DPO Case File for DPO-2005-002

The following pdf represents a collection of documents associated with the submittal and disposition of a differing professional opinion (DPO) from an NRC employee involving Red Oil events at proposed MFFF.

DIFFERING PROFESSIONAL OPINION ON
RED OIL EVENTS AT THE
PROPOSED MIXED OXIDE (MOX) FUEL FABRICATION FACILITY
DOCKET NUMBER: 070-03098

Figure A: Comparison of the Applicant's Red Oil Safety Strategies with DOE/DNFSB (formerly Open Item CS-01) Recommendations

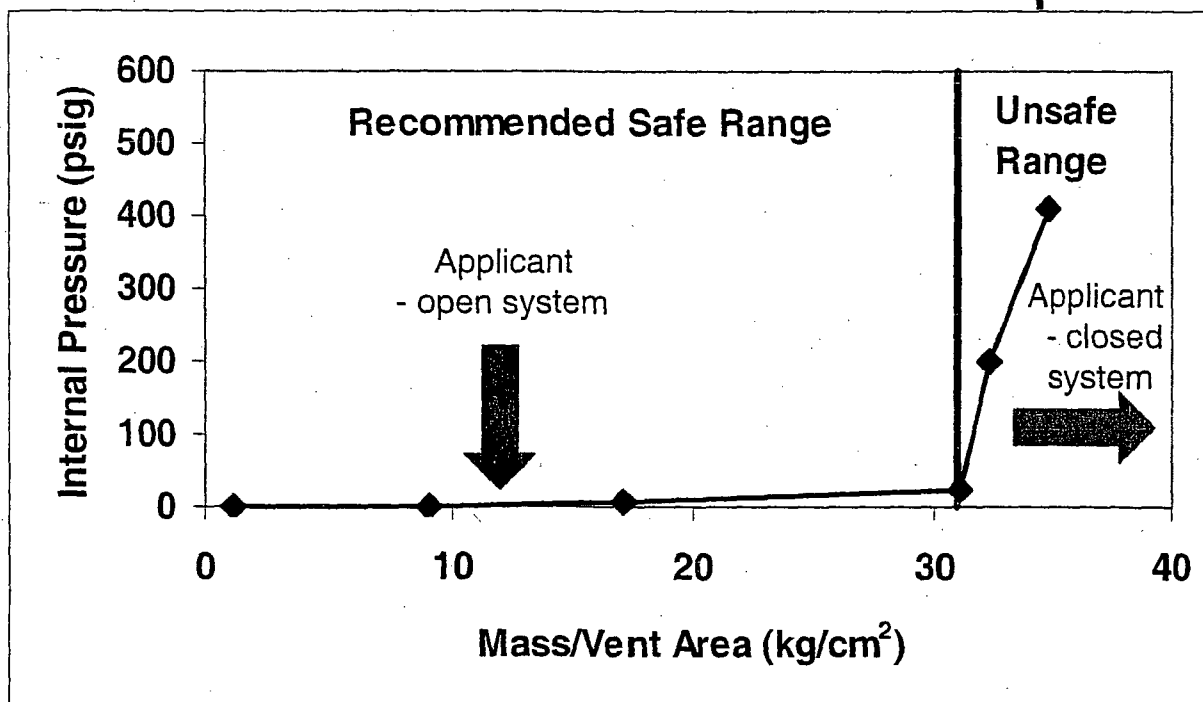
1. Contradictions with DOE/DNFSB RAGAGEP (Reasonable And Generally Accepted Good Engineering Practice) are not explained. In particular, the RAGAGEP shows the applicant's proposal for closed systems being entirely in the unsafe regime (Figure 2).
2. There is inadequate margin in the design basis temperature.
3. The venting is insufficient to avoid choked flow and pressurization, which has the ability to rapidly raise the temperature even with the applicant's proposed strategy functioning.

Figure 2: Comparison of the Applicant's Red Oil Safety Strategies with DOE/DNFSB (formerly Open Item CS-01) Recommendations

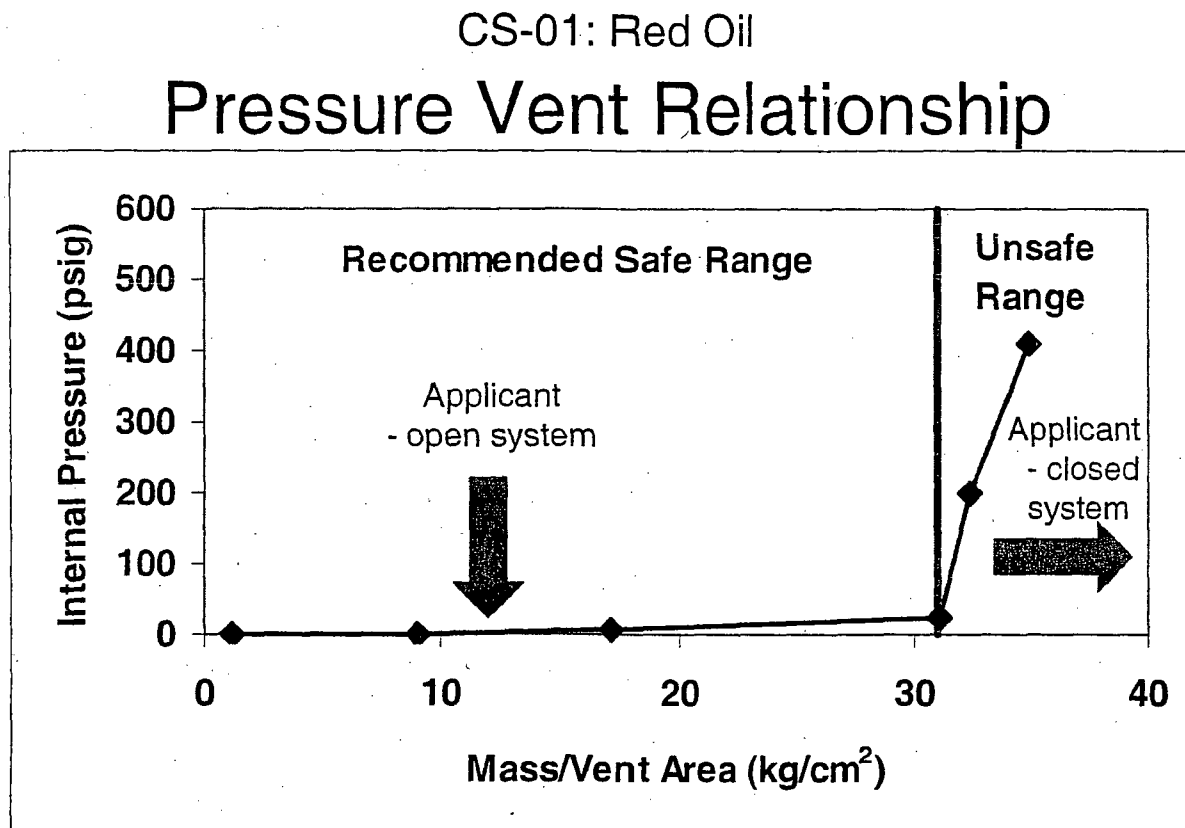
1. Contradictions with DOE/DNFSB RAGAGEP are not explained. In particular, the RAGAGEP shows the applicant's proposal for closed systems being entirely in the unsafe regime (Figure 2).

- **Pressure/Venting:** DOE/DNFSB use a pressure/vent relationship (Figure 2) that is well within the safe range identified from experimental testing. The applicant's approach for open systems is also well within the safe range. In contrast, the applicant's approach for closed systems (i.e., evaporative cooling) far exceeds the safe limit and is well into the unsafe range. Common mode failure is likely - reaction products from the red oil reactions cannot escape and provide evaporative cooling, resulting in choked flow, which increases temperature, resulting in suppressed evaporation, which increases temperature, resulting in increased red oil reaction rates etc. - ultimately, this leads to a runaway reaction and explosion. The loss of evaporative cooling effectiveness above 120 C is noted in articles cited in the staff's DSER and RDSER.

1. Contradictions with DOE/DNFSB RAGAGEP are not explained. In particular, the RAGAGEP shows the applicant's proposal for closed systems being entirely in the unsafe regime (Figure 2).
2. There is inadequate margin in the design basis temperature.
3. The venting is insufficient to avoid choked flow and pressurization, which has the ability to rapidly raise the temperature even with the applicant's proposed strategy functioning.

Figure 2: Comparison of the Applicant's Red Oil Safety Strategies with DOE/DNFSB (formerly Open Item CS-01) Recommendations

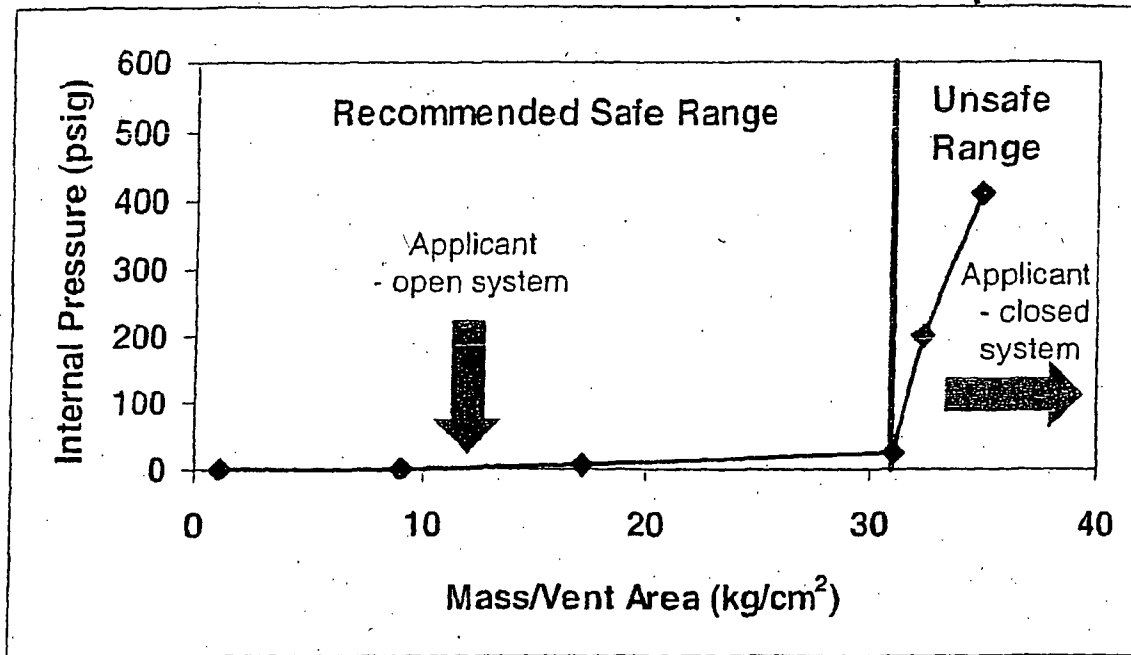
- **Pressure/Venting:** DOE/DNFSB use a pressure/vent relationship (Figure 2) that is well within the safe range identified from experimental testing. The applicant's approach for open systems is also well within the safe range. In contrast, the applicant's approach for closed systems (i.e., evaporative cooling) far exceeds the safe limit and is well into the unsafe range. Common mode failure is likely - reaction products from the red oil reactions cannot escape and provide evaporative cooling, resulting in choked flow, which increases temperature, resulting in suppressed evaporation, which increases temperature, resulting in increased red oil reaction rates etc. - ultimately, this leads to a runaway reaction and explosion. The loss of evaporative cooling effectiveness above 120 C is noted in articles cited in the staff's DSER and RDSER.

1. Contradictions with DOE/DNFSB RAGAGEP are not explained. In particular, the RAGAGEP shows the applicant's proposal for closed systems being entirely in the unsafe regime (Figure 2).
2. There is inadequate margin in the design basis temperature.
3. The venting is insufficient to avoid choked flow and pressurization, which has the ability to rapidly raise the temperature even with the applicant's proposed strategy functioning.

Figure 2: Comparison of the Applicant's Red Oil Safety Strategies with DOE/DNFSB (formerly Open Item CS-01) Recommendations

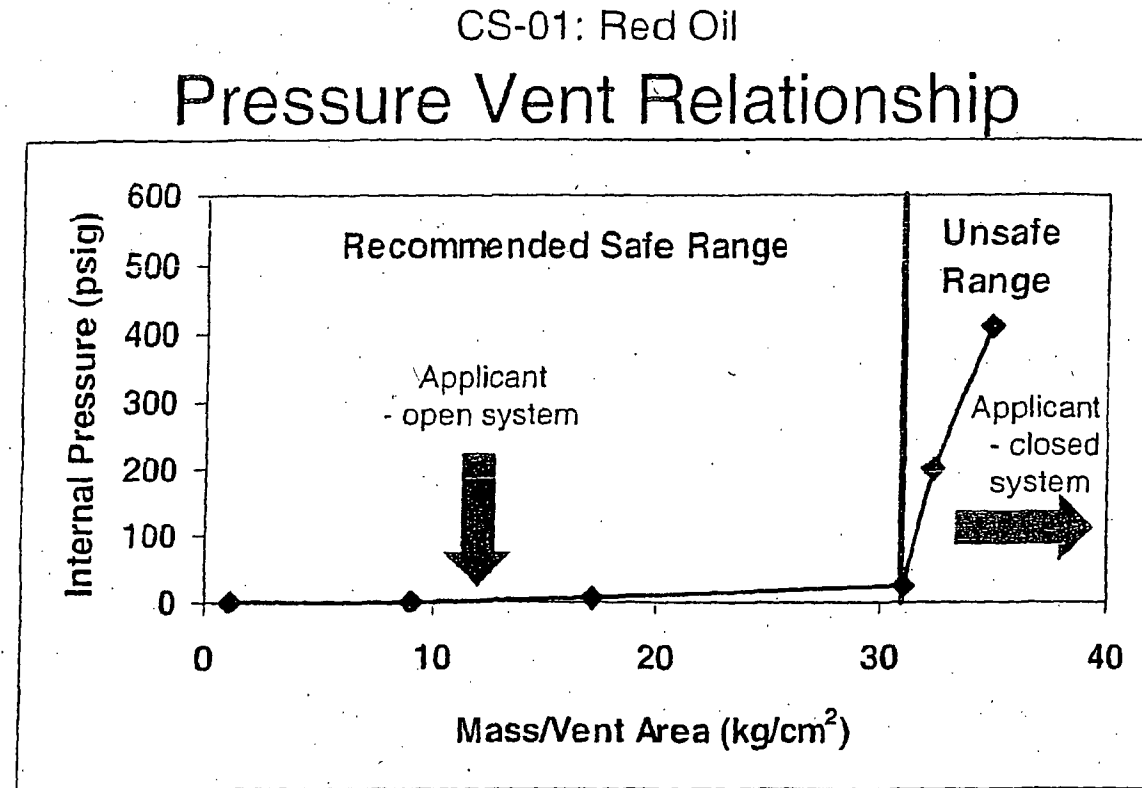
- **Pressure/Venting:** DOE/DNFSB use a pressure/vent relationship (Figure 2) that is well within the safe range identified from experimental testing. The applicant's approach for open systems is also well within the safe range. In contrast, the applicant's approach for closed systems (i.e., evaporative cooling) far exceeds the safe limit and is well into the unsafe range. Common mode failure is likely - reaction products from the red oil reactions cannot escape and provide evaporative cooling, resulting in choked flow, which increases temperature, resulting in suppressed evaporation, which increases temperature, resulting in increased red oil reaction rates etc. - ultimately, this leads to a runaway reaction and explosion. The loss of evaporative cooling effectiveness above 120 C is noted in articles cited in the staff's DSER and RDSER.

1. Contradictions with DOE/DNFSB RAGAGEP are not explained. In particular, the RAGAGEP shows the applicant's proposal for closed systems being entirely in the unsafe regime (Figure 2).
2. There is inadequate margin in the design basis temperature.
3. The venting is insufficient to avoid choked flow and pressurization, which has the ability to rapidly raise the temperature even with the applicant's proposed strategy functioning.
